# Fosse Green Energy

EN010154

## 9.19 Applicant's Response to the Examining Authority's Second Written Questions

20 March 2026

**PROJECT**

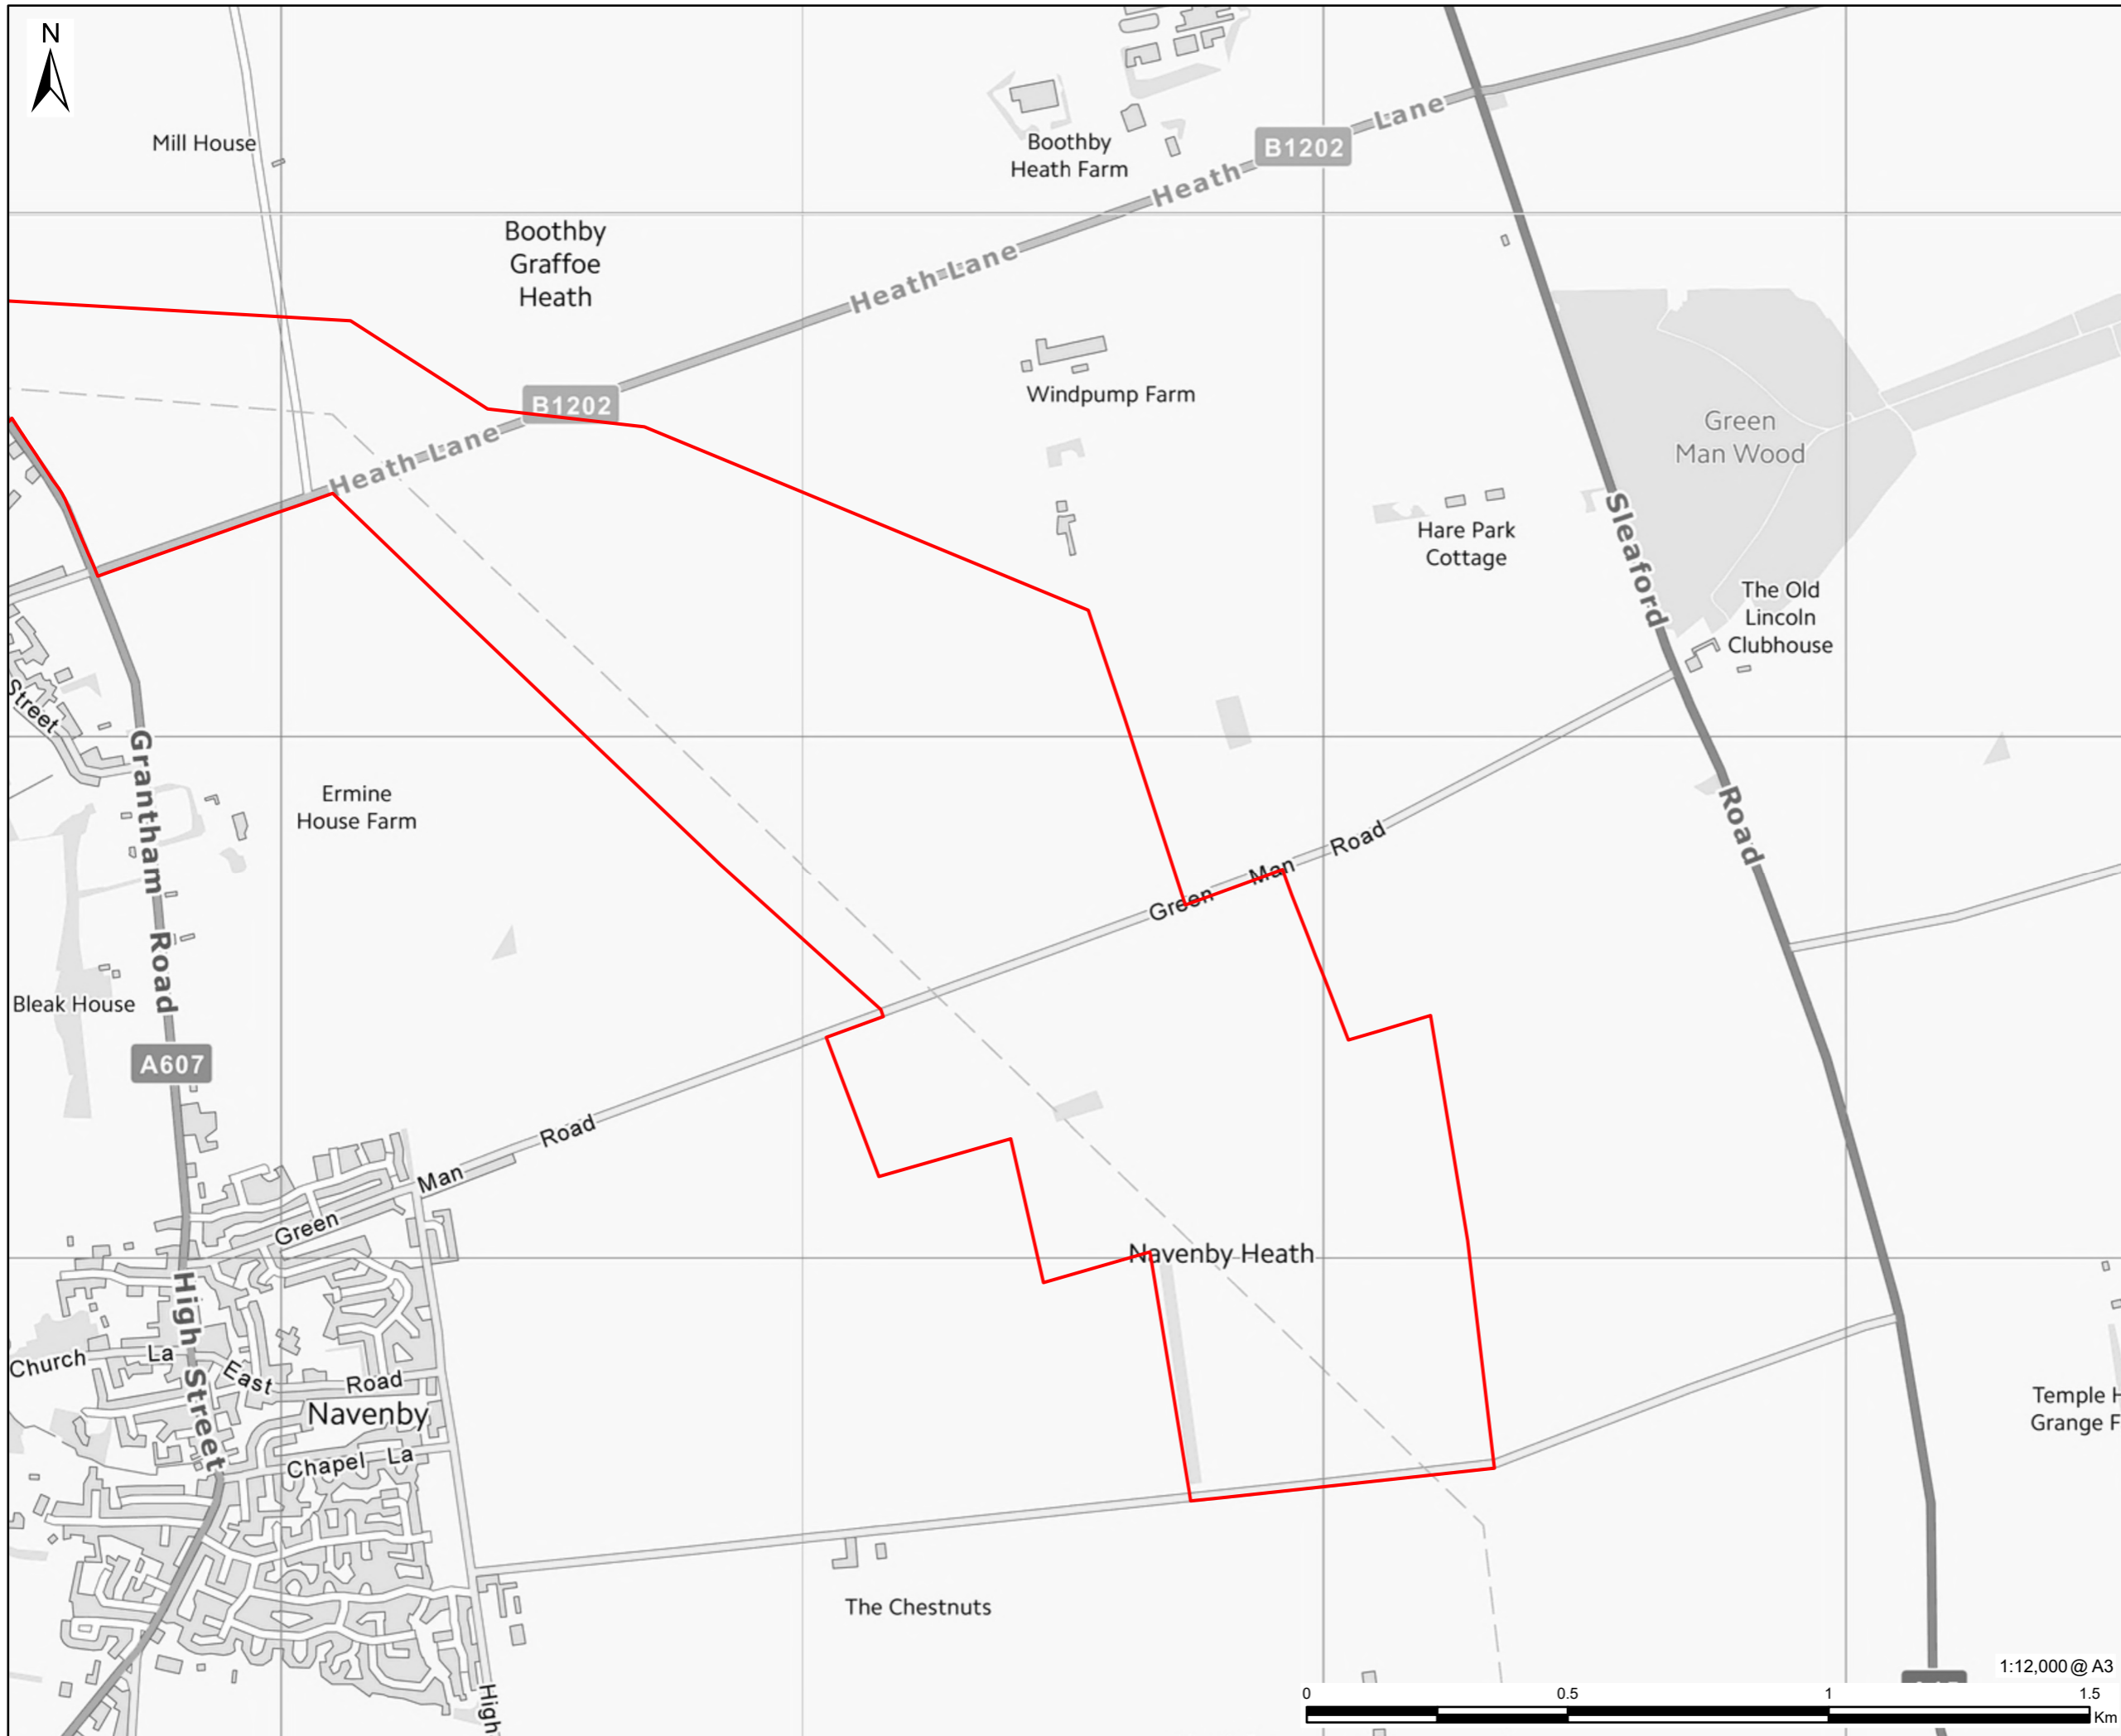
Question Number	Question to:	Question	Applicant Response
<b>Landscape and Visual (LV)</b>			
LV.2.01	Applicant	<p><b>Plans showing the locations for viewpoints and photomontages</b> The ExA notes the applicant's response to ExQ1 LV.1.01 (Plans showing the locations for viewpoints and photomontages), most particularly the reliance placed on ES Figure 10-7 Zone of Theoretical Visibility – Barrier Earth, with Viewpoint Locations (Rev B) [AS-059] as the means for identifying the locations for the viewpoints and photomontages used in the submitted assessment of the proposed development's landscape and visual amenity effects. However, ES Figure 10-7 [AS-059] is affected by limited contextual mapping information relating to road/street and property naming that the ExA referred to in item 1(a) in its procedural decision letter dated 22 August 2025 [PD-005]. That, taken together with the scale of ES Figure 10-7 (1:60,000), makes it difficult to identify the precise locations for some of the viewpoints and photomontages without recourse to other submitted figures.</p> <p>The ExA therefore considers the answer to ExQ1 LV.1.01 to be unsatisfactory. Accordingly, the applicant should submit a plan (or plans) appropriately scaled with adequate contextual information to enable the locations for the viewpoints and photomontage to be clearly identified.</p>	<p>Please see Figure WQ2-1 provided in Appendix A, which illustrates the location of the viewpoints at a 1:12,000 scale with additional contextual location information.</p> <p>Figure 10-8 Viewpoint Photography [APP-095] and Figure 10-10: Photomontages [APP-097] and [AS-119] of the ES also provide locational information (such as location coordinates) beneath each respective image.</p>

Figure WQ2-2: Proximity of Local Wildlife Sites to the Proposed Development

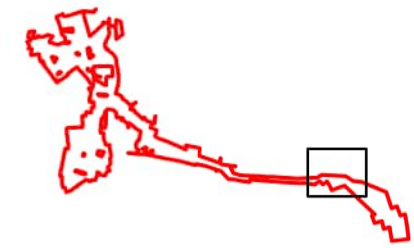
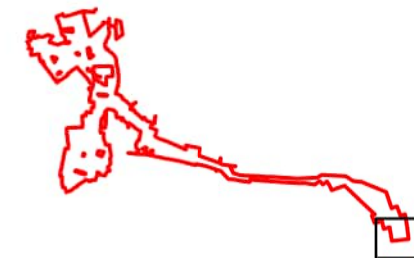
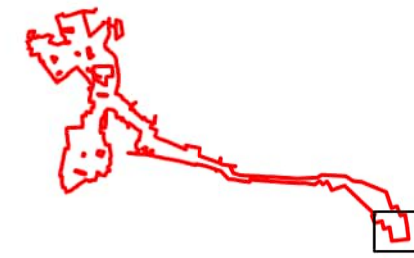
ENC.2.07	Lincolnshire Wildlife Trust	<p><b>Navenby Green Man Road Verges LWS</b> Explain what more detail you require on where and how the LWS would be impacted in addition to what is presented in Tables 8-13 and 8-14 and paragraphs 8.12.5 to 8.12. 9 in ES Chapter 8 [REP1-019].</p>	N/A
ENC.2.08	Applicant Lincolnshire Wildlife Trust	<p><b>Grass Verges LWSs</b> In its Deadline 2 response [REP2-055], Lincolnshire Wildlife Trust requests evidence in the form of a detailed map showing the proposed development's relationship with other grass verge LWSs, namely Boothby Graffoe Road Verge; High Dike, Coleby Mill to Harmston Verges; Gorse Lane; and Navenby Heath Road Verges.</p> <p>The assessment in Table 8-14 in [REP1-019] concludes that there would be no potential for an effect to occur on Navenby Heath Road Verges, Gorse Lane, High Dike and Coleby Mill to Harmston Verges. Table 8-9 in [REP1-019] identifies that the Boothby Graffoe Road Verge is around 595m from the site.</p> <p>a) <b>Applicant</b> - Confirm whether the plan requested by Lincolnshire Wildlife Trust can be provided. b) <b>Lincolnshire Wildlife Trust</b> - Would the provision of this plan together with the information presented in [REP1-019] provide sufficient evidence for you to conclude whether there would or would not be any impacts on the LWSs?</p>	<p>A detailed plan of the DCO Site in relation to Boothby Graffoe Road Verge Local Wildlife Site (LWS), High Dike, Coleby Mill to Harmston Verges LWS, Gorse Lane LWS, and Navenby Heath Road Verges LWS is provided in Appendix A (see Figure WQ2-2).</p> <p>As stated in Chapter 8: Ecology and Nature Conservation of the ES [REP1-019] there would be no potential for an effect to occur to any of these LWS, noting that whilst Navenby Heath Road Verges LWS is shown partly within the DCO Site, it will not be directly impacted and will be protected and buffered from the Proposed Development. Further details of any proposed development in relation to this area of the DCO Site close to the Navenby Heath Road Verges LWS is provided on Sheet 16 in the Streets, Rights of Way and Access Plans [REP2-004].</p>
